FOR DA PURPOSES ONLY
NOT FOR CONSTRUCTION

PROJECT:
1 LAWSON SQUARE, REDFERN
CLIENT:
LAWSON SQUARE PTY LTD.
SCALE:
1:200 @ A1
DATE:
SEPTEMBER 2017
CHECKED 1:
RY
CHECKED 2:
JE
APPROVED:
=

DRAWING:
**ELEVATIONS SHEET 3
TOWER 2 - EAST & WEST ELEVATIONS**
DRAWING No:
S96 - 1303

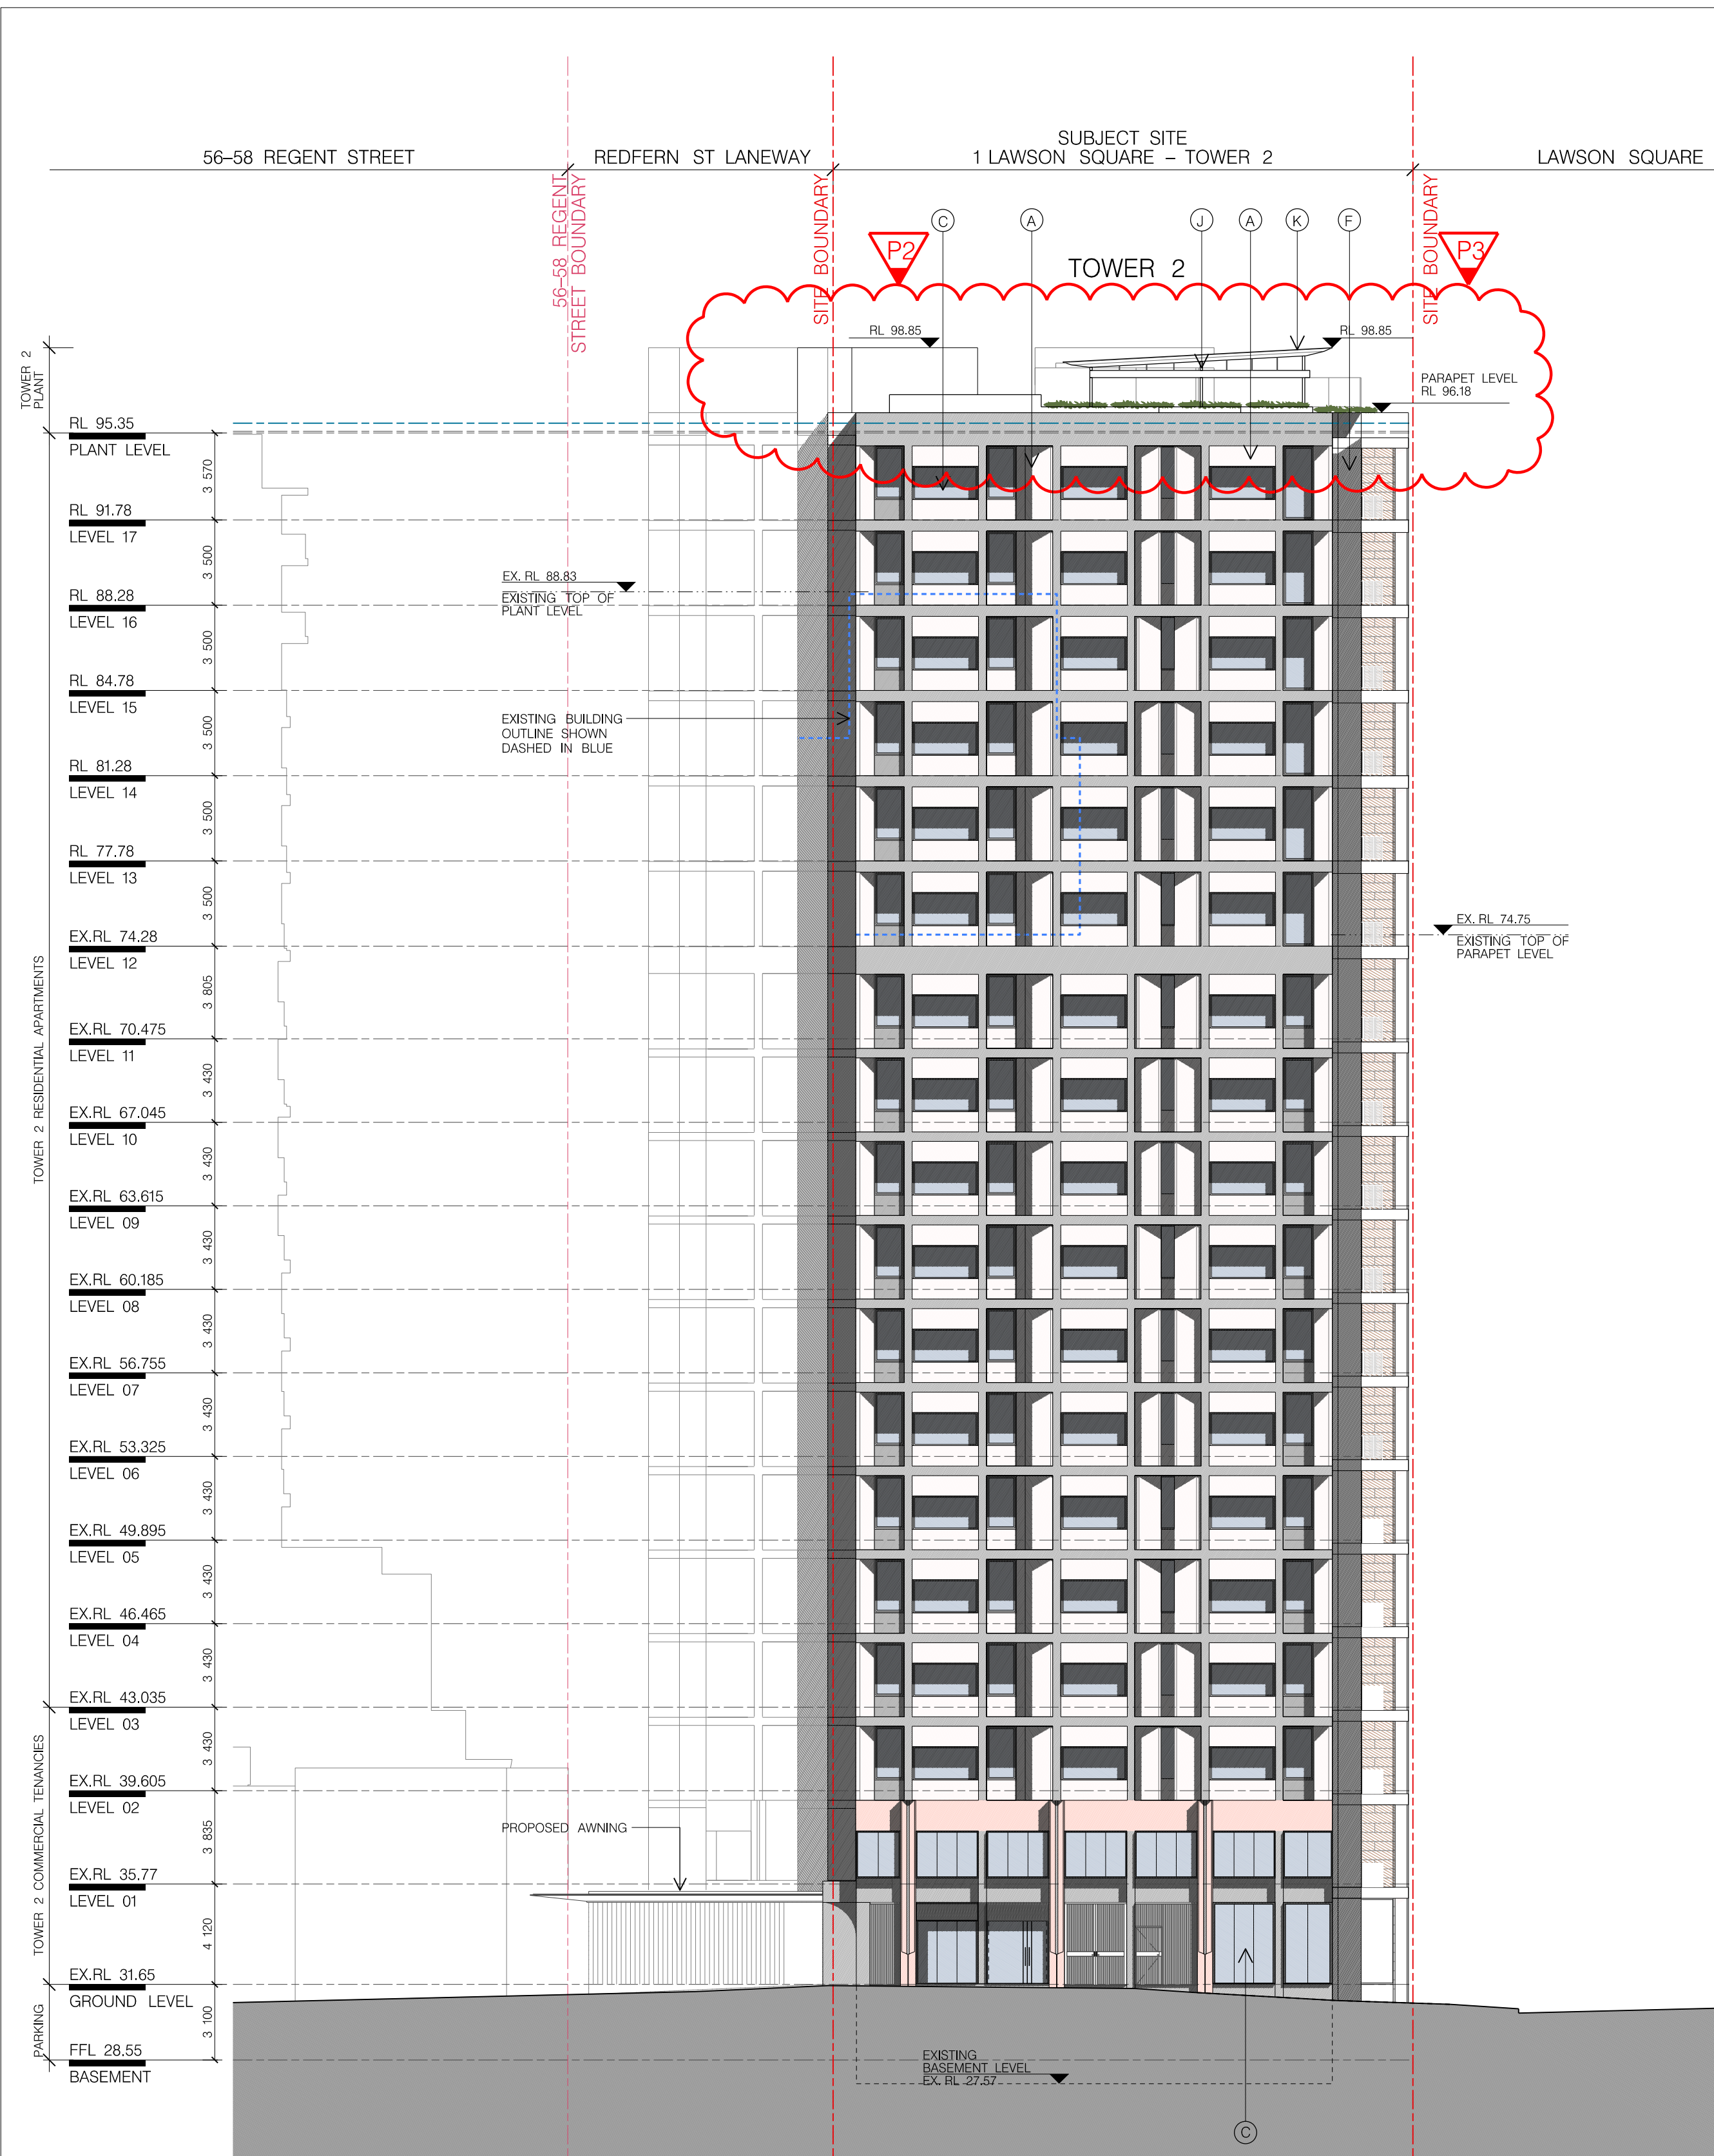
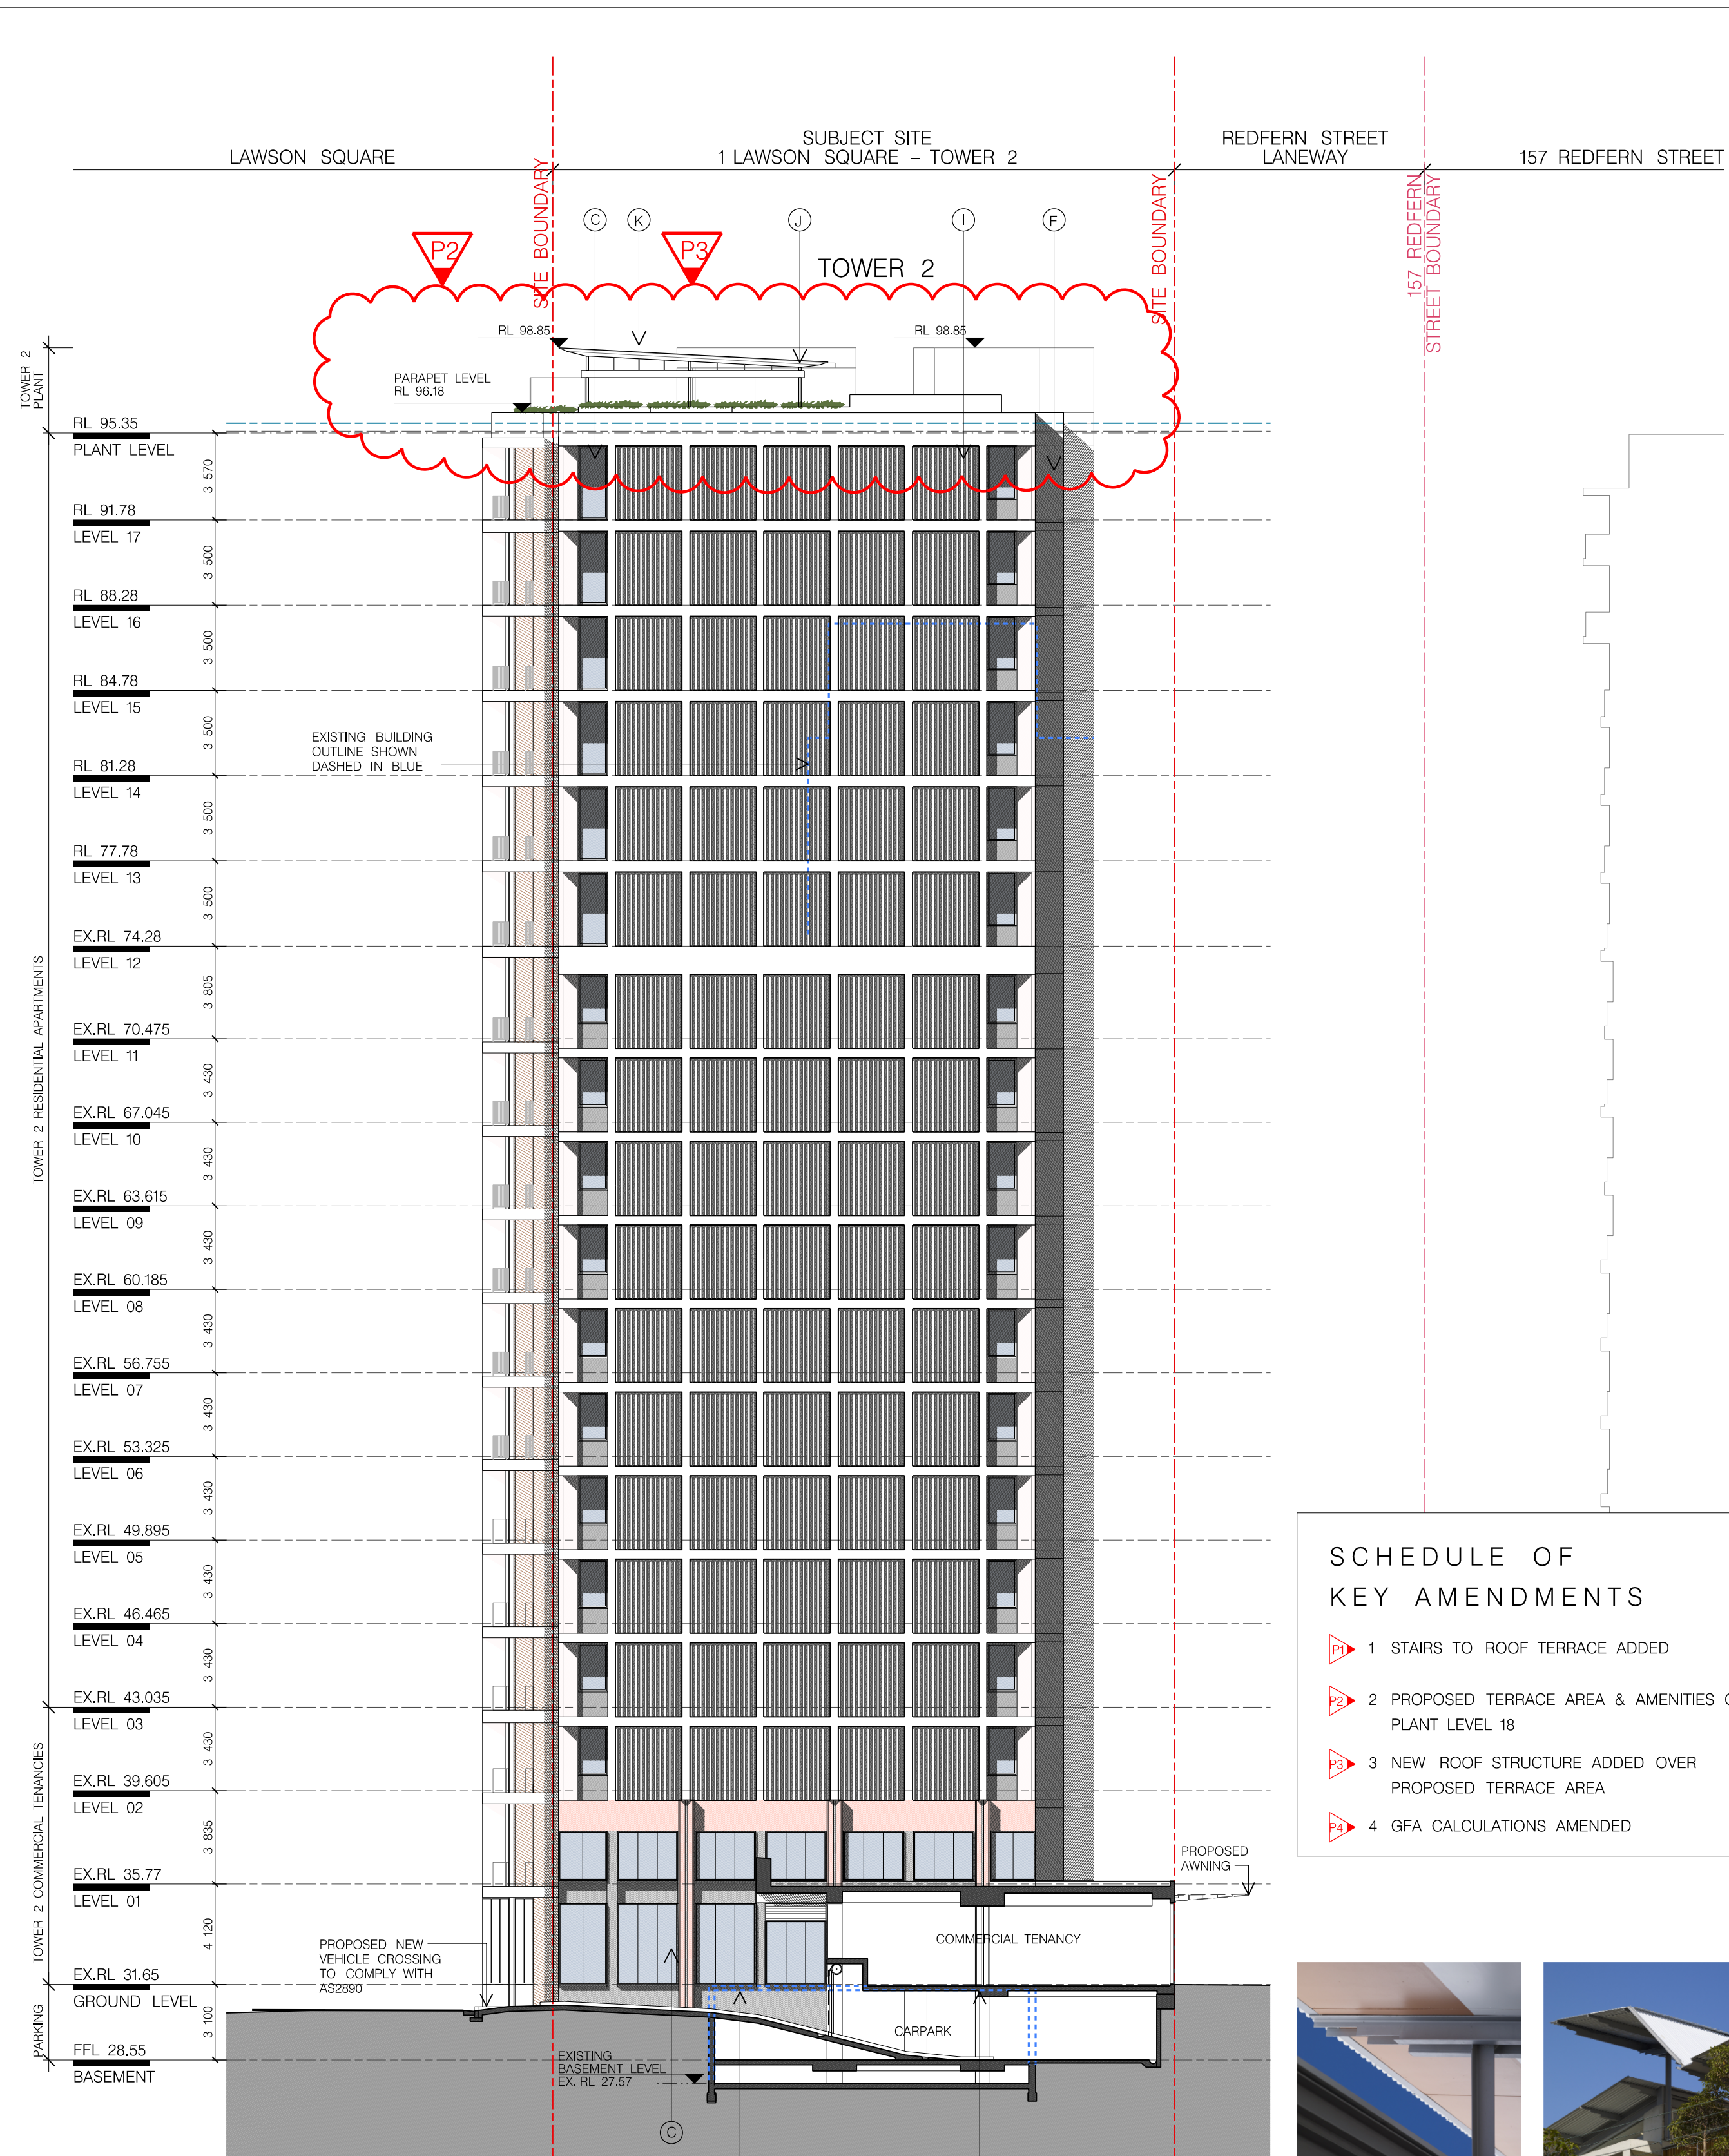
SCHEDULE OF KEY AMENDMENTS	
1	STAIRS TO ROOF TERRACE ADDED
2	PROPOSED TERRACE AREA & AMENITIES ON PLANT LEVEL 18
3	NEW ROOF STRUCTURE ADDED OVER PROPOSED TERRACE AREA
4	GFA CALCULATIONS AMENDED
